Access Compliance Report

Public Rights-of-Way

(Curb Ramps)

| Intersection ID: 10033070 | Main Street: NORTH_COMMUNITY_HOUSE_RD | Cross Street: N/A | Location: NE |

| ADA ID: CDF1215B4830 | Ramp Type: Perp | Initial Pass/Fail: Fail | Overall Compliance: No |

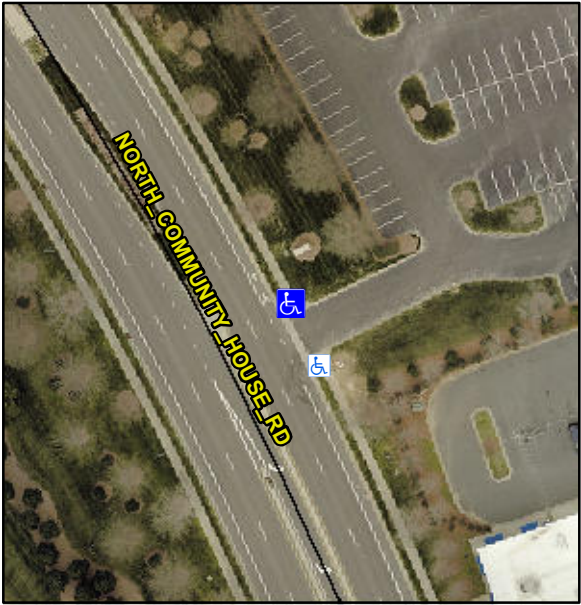
| Codes/Mitigation Info/Possible Solution | | | Field Measurements/Component Compliance | | |
|--|--|------------|---|-----------------------------|-------------|
| | | | No | Ramp Width (in) | 37.5 |
| Not Found, R304.5.1 | | | | | |

| Codes/Mitigation Info/Possible Solution | | | Field Measurements/Component Compliance | | |
|--|--|------------|---|-----------------------------|-------------|
| | Remove & Replace Entire Ramp. | | Yes | Ramp Length (in) | 56.0 |
